FINAL
ENVIRONMENTAL IMPACT STATEMENT

URS Corporation
1421 Chapala Street
Santa Barbara, California 93101

This is a programmatic environmental impact statement (EIS) for adoption of the proposed Mineral Resource Management Plan (MRMP) for Vandenberg Air Force Base (VAFB).

Figure 3.8-1
PRINCIPAL TRANSPORTATION ACCESS TO VAFB

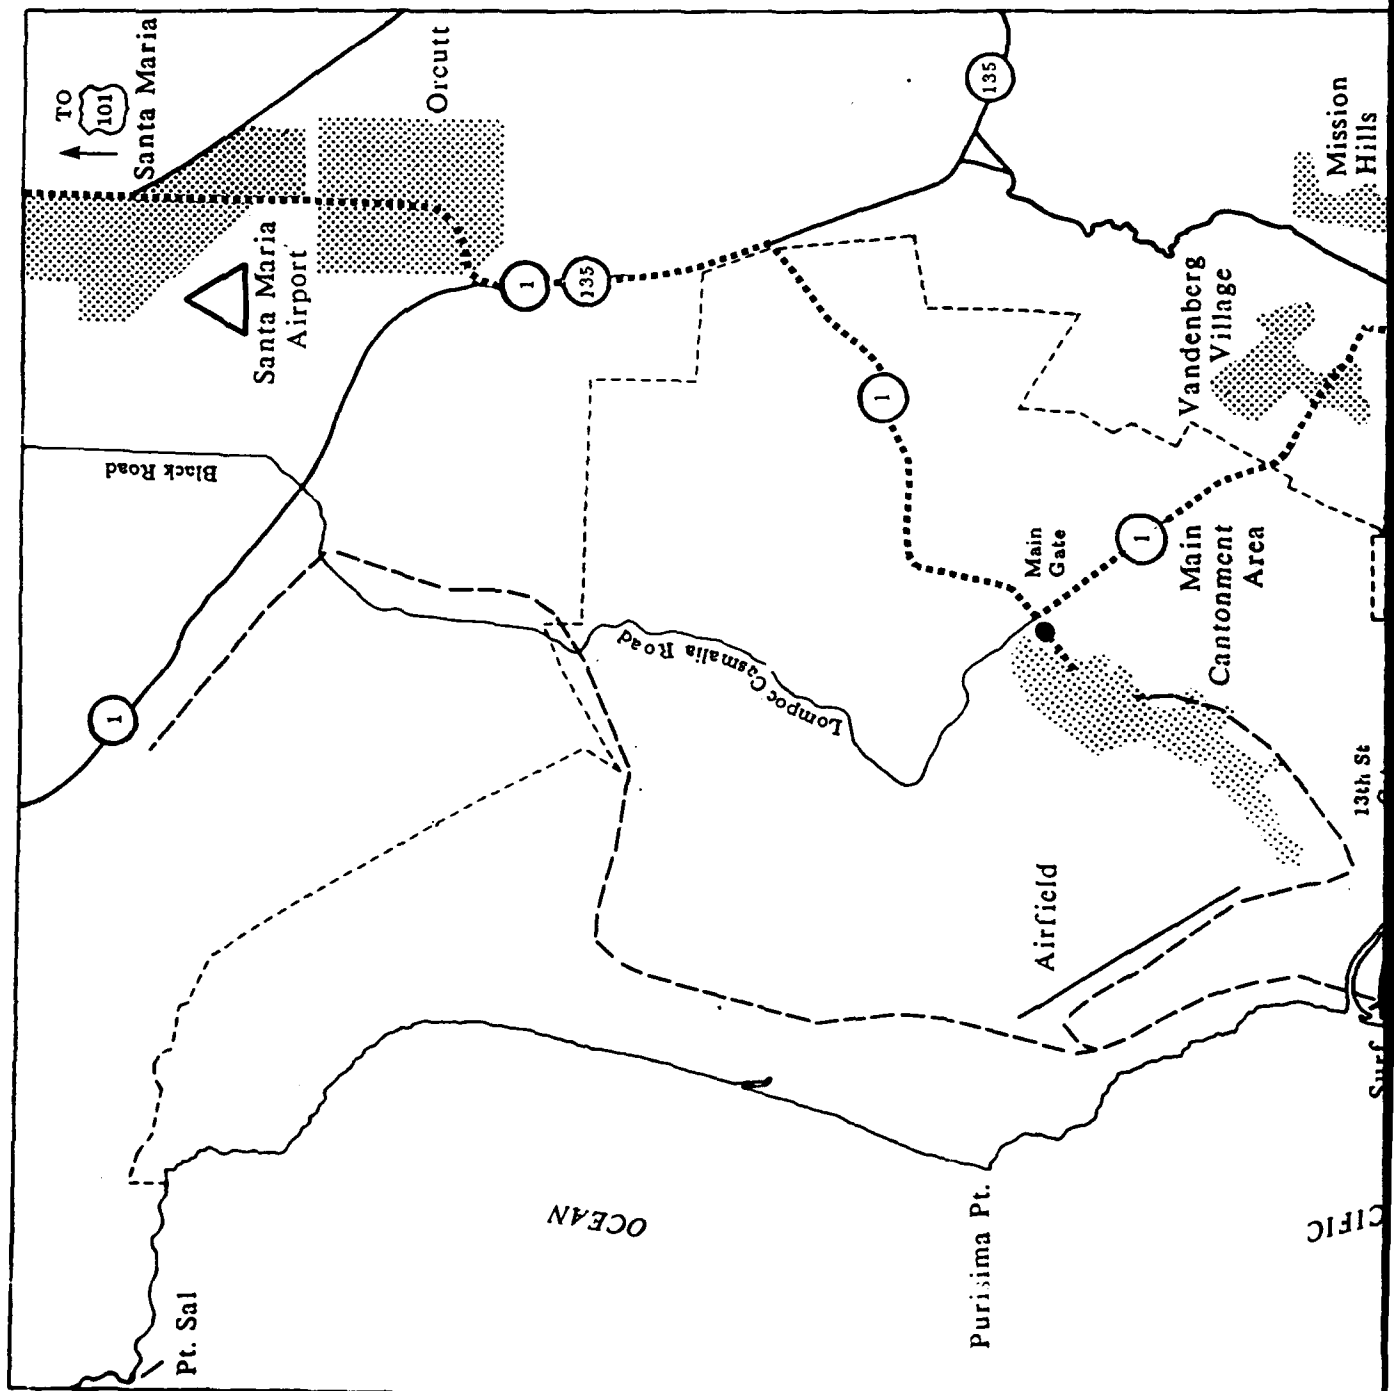
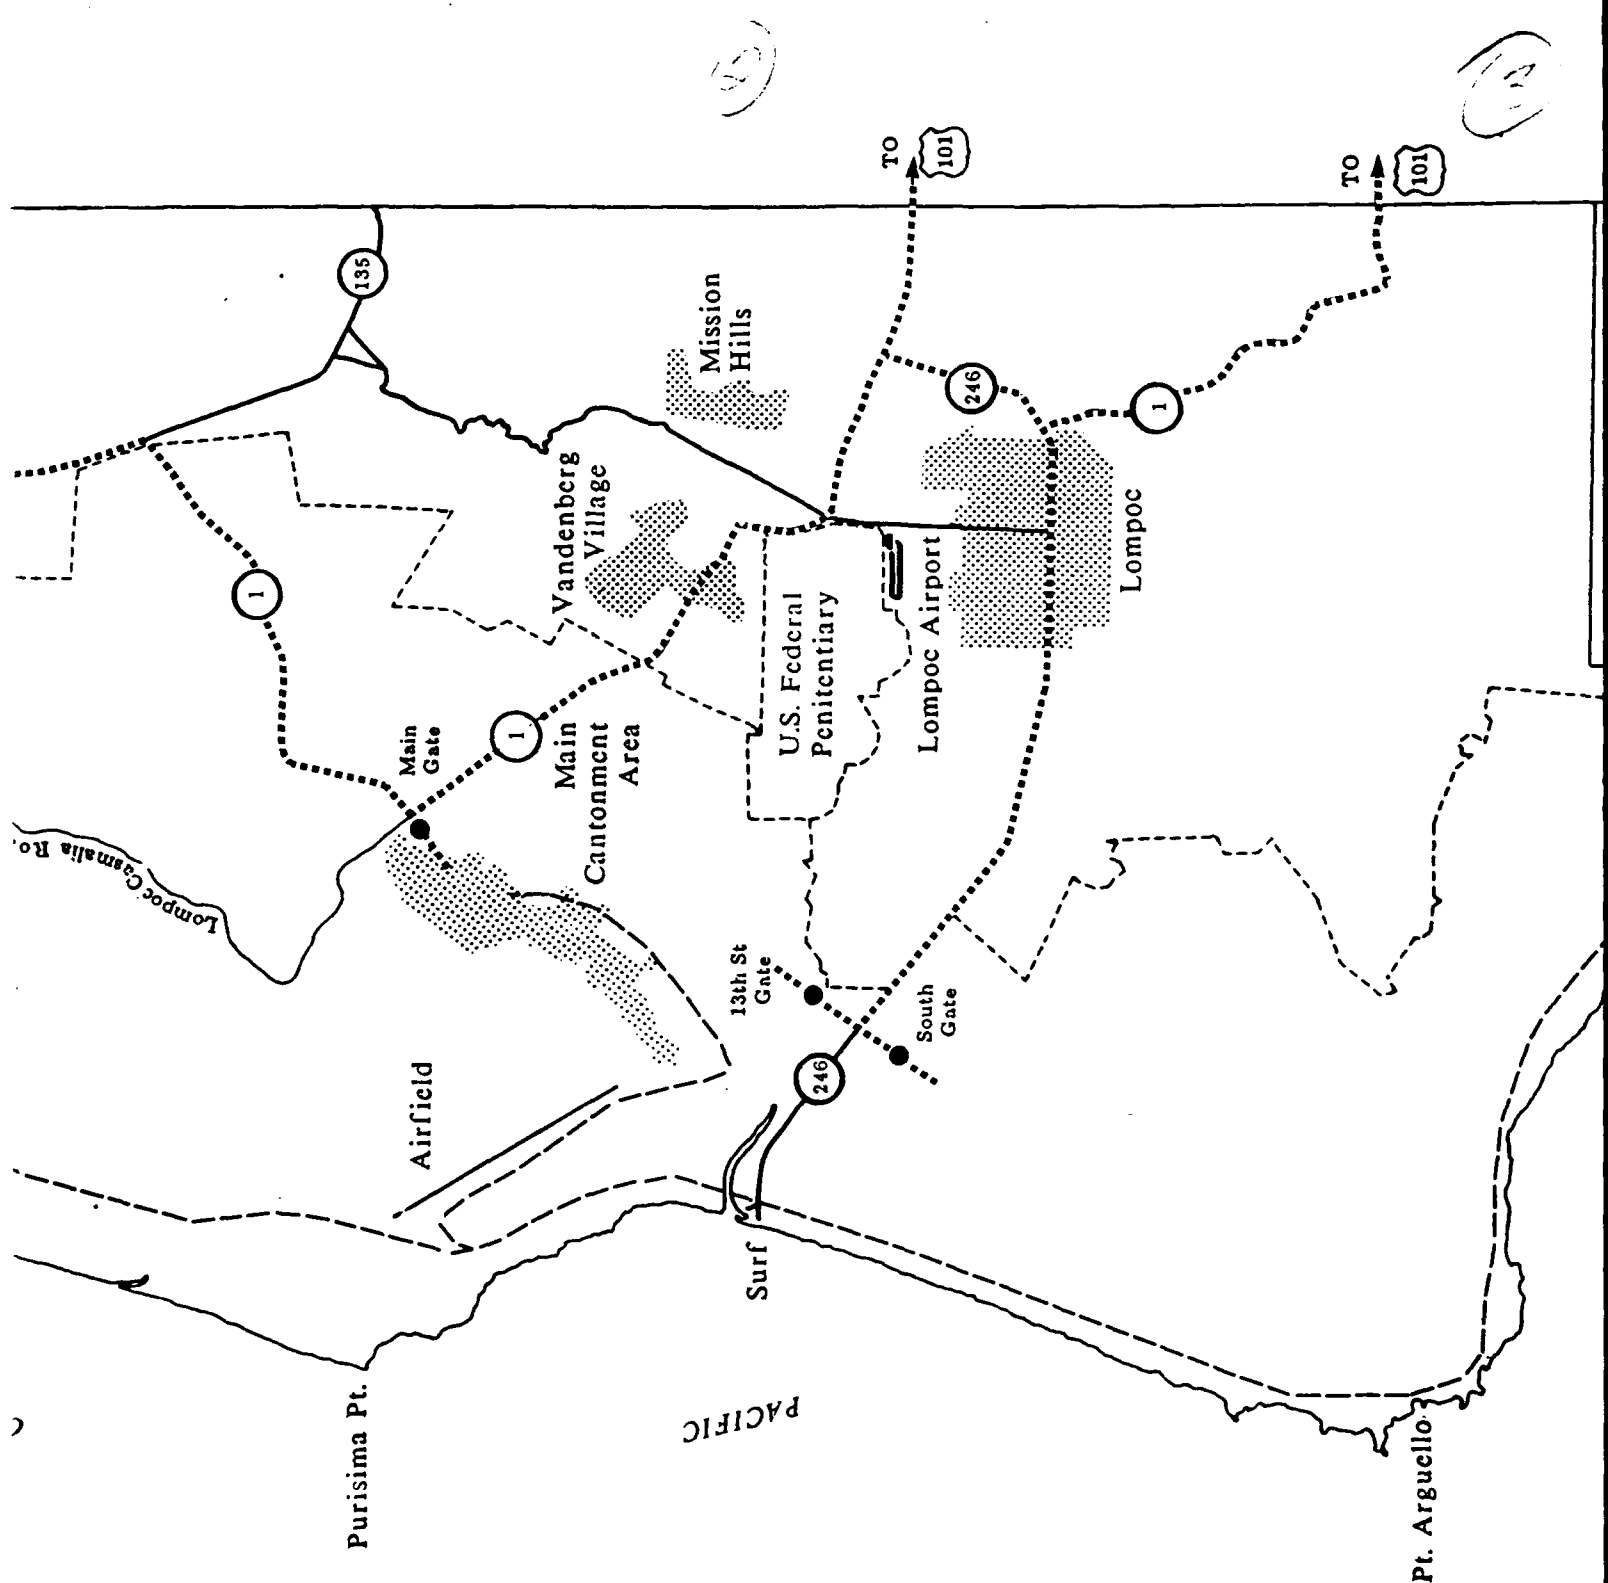
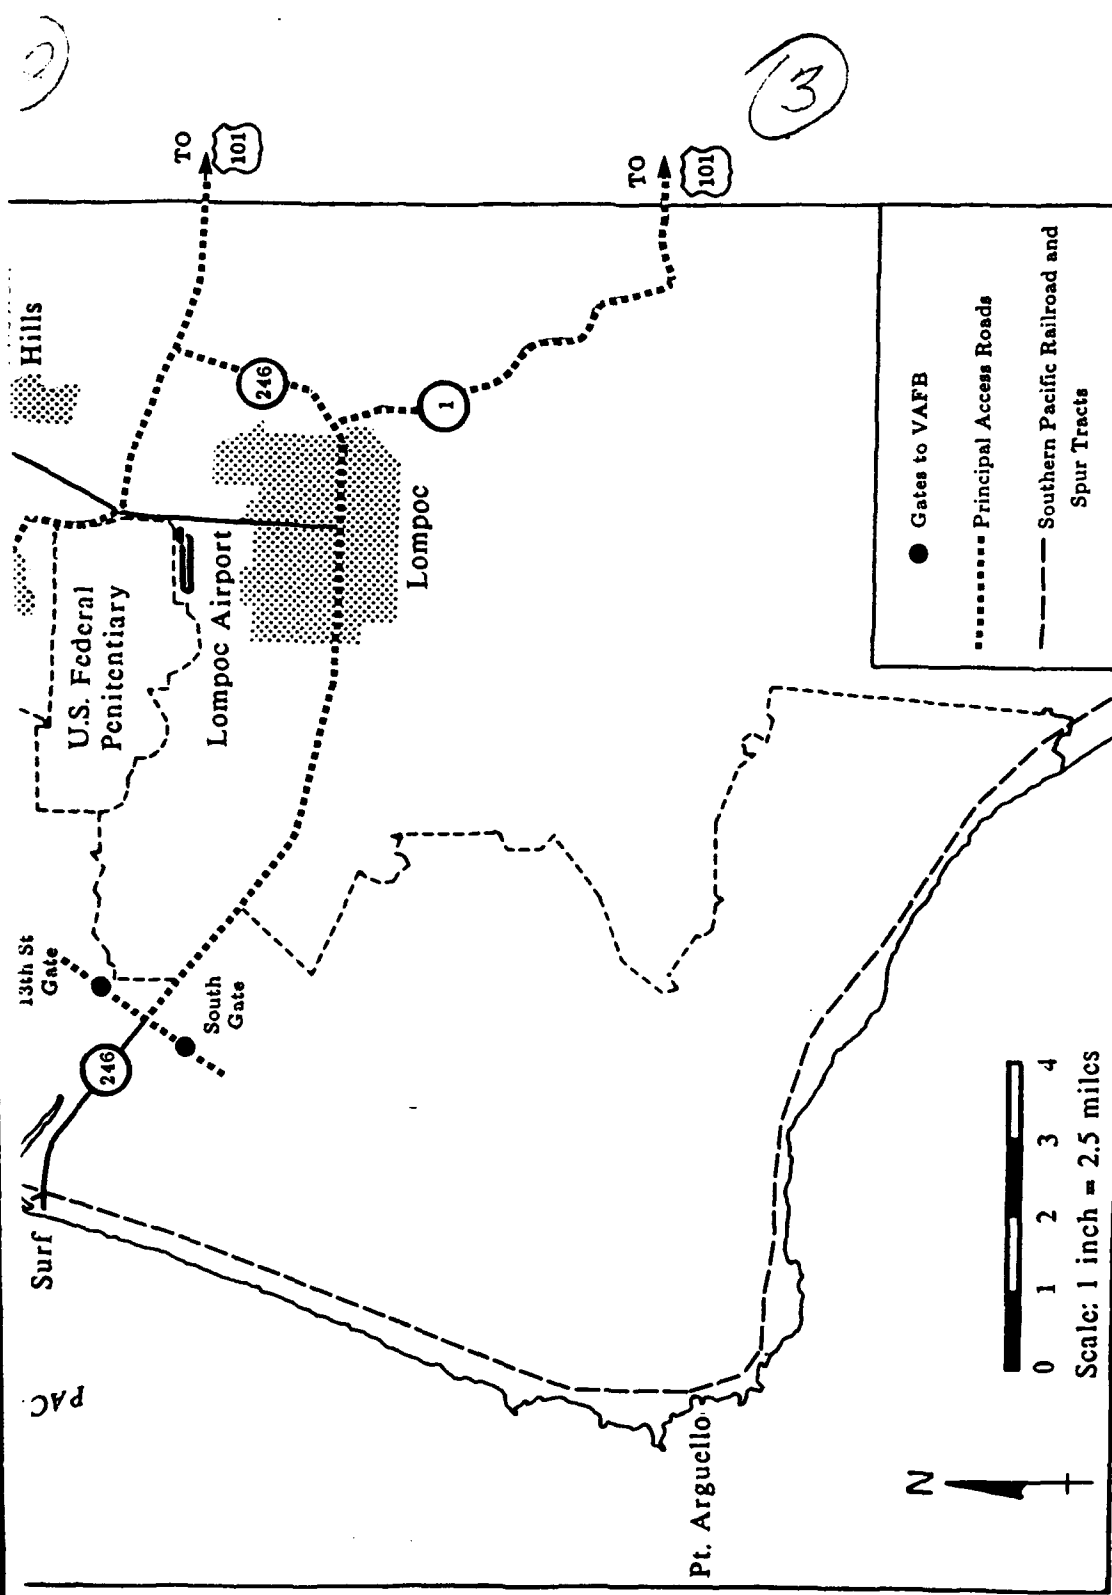
Figure 3.8-1 on page 3.8-3 has been revised. Please see the attached figure.

Figure 4.9-3
STEAM GENERATOR

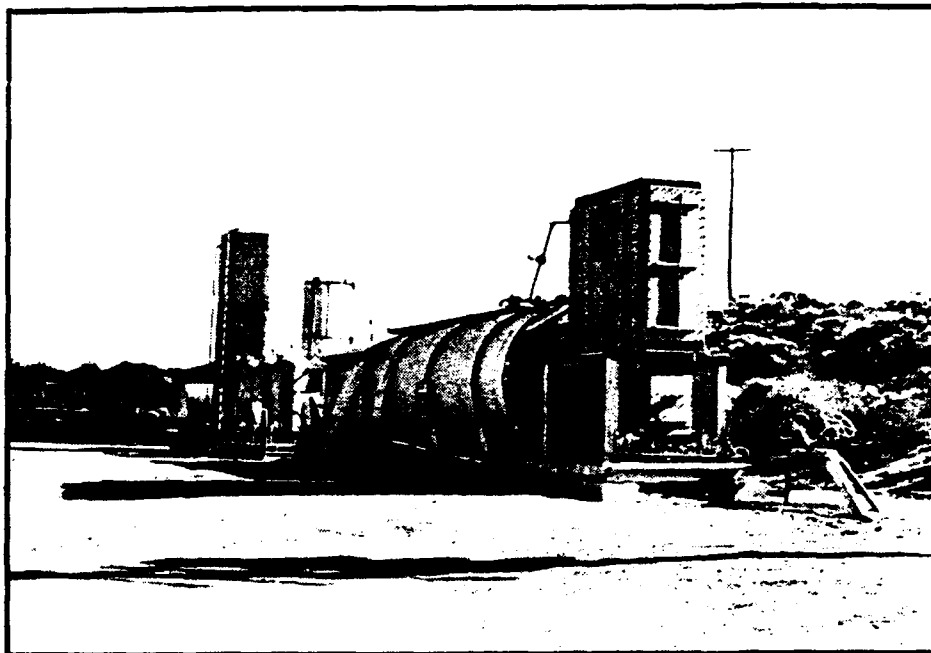
Figure 4.9-3 on page 4.9-5 has been retitled "Steam Generator" as shown on the attached figure.

Figure 4.9-3 is incorrectly titled "H₂S Scrubber". This photograph actually depicts a steam generator.

Figure 5-1
PHYSIOGRAPHIC FEATURES

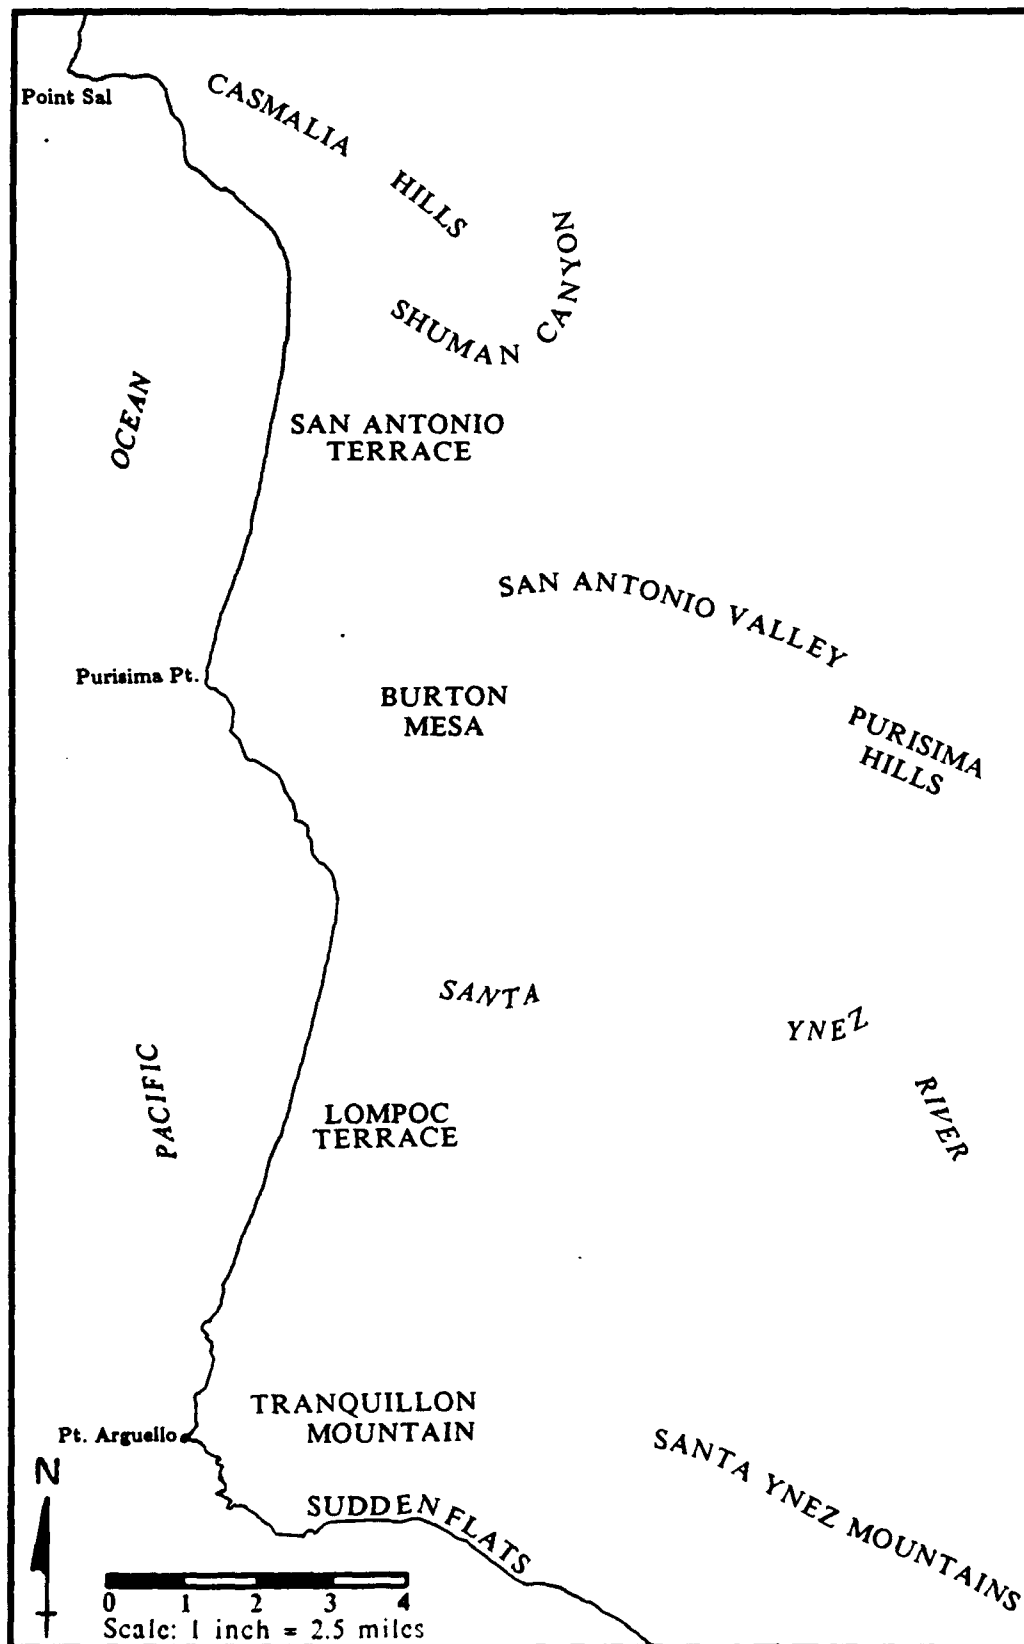
Figure 5-1 - Point Conception is incorrectly located

Figure 5-1 on page 5-2 has been revised. The words "Point Conception" no longer appear (see the attached figure).

Figure 6.5-3
INITIAL COMPLIANCE ACTIVITIES

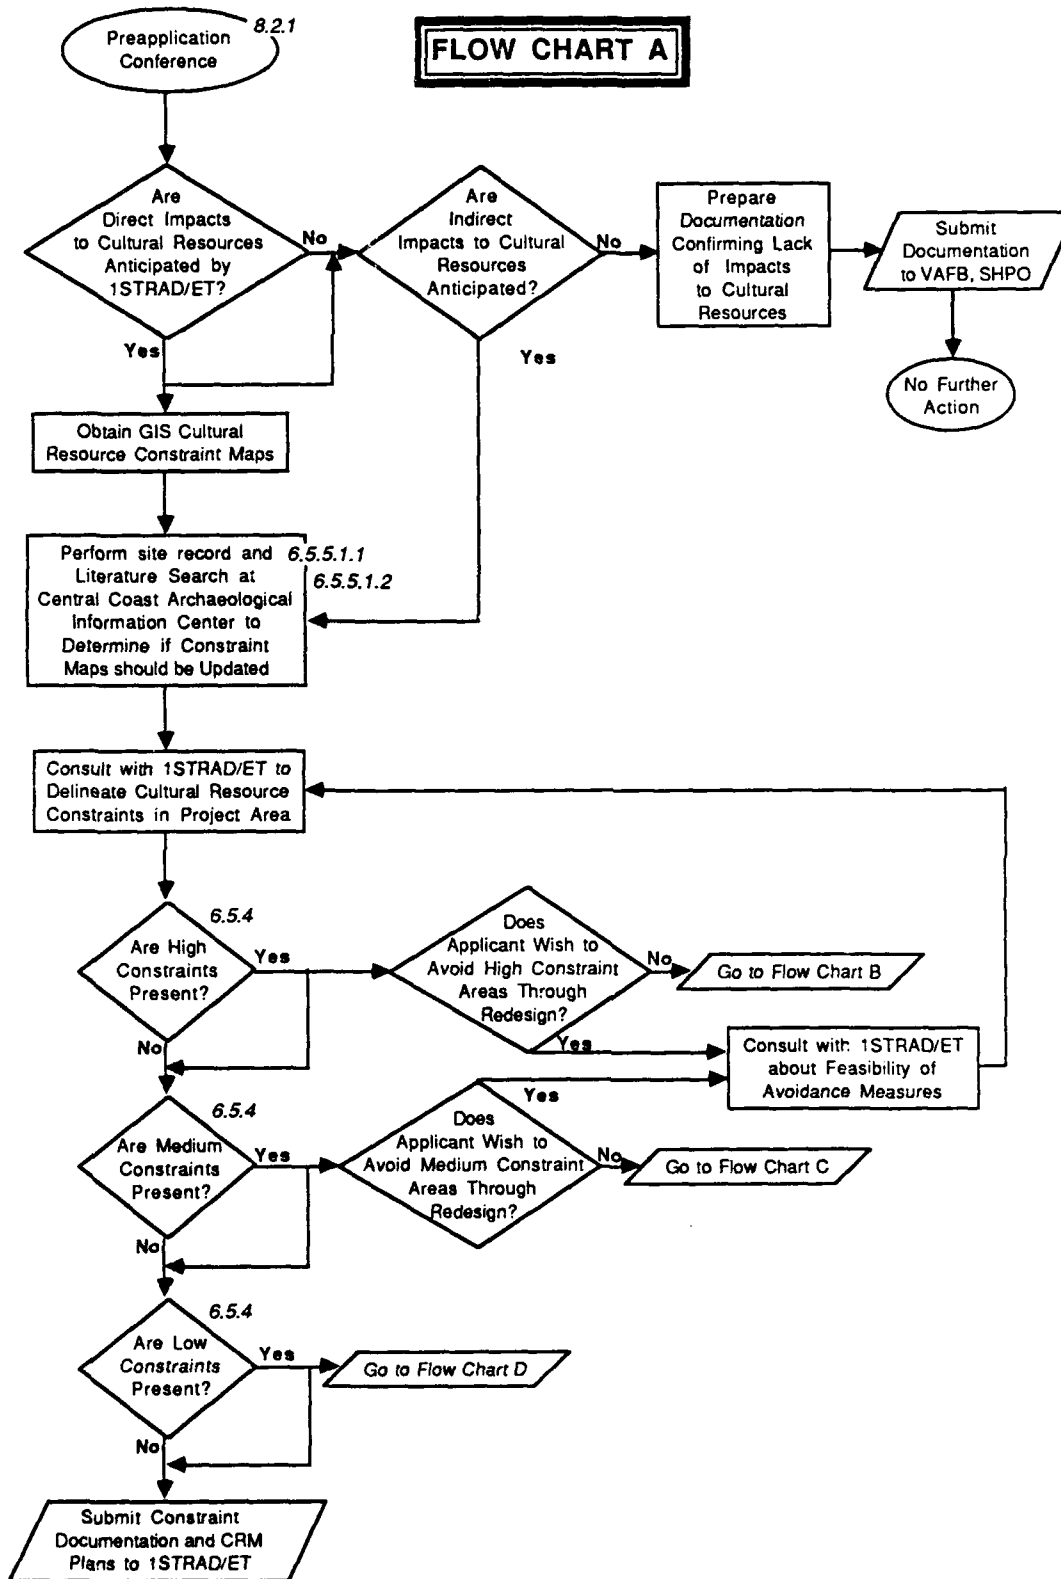
Page 6.5-22, Figure 6.5-3 is replaced with the attached.

investigations. Project applicants should consult closely with the U.S. Air Force so that project redesign can be initiated as early as possible. Figure 6.5-3 (Flow Chart A) of the MRMP has been modified to show that avoidance can be implemented after the preapplication conference between the U.S. Air Force and project applicant and before boundary definition is necessary. In this way, an efficient process would be assured. Please see the MRMP errata for section 6.5, Cultural Resources.
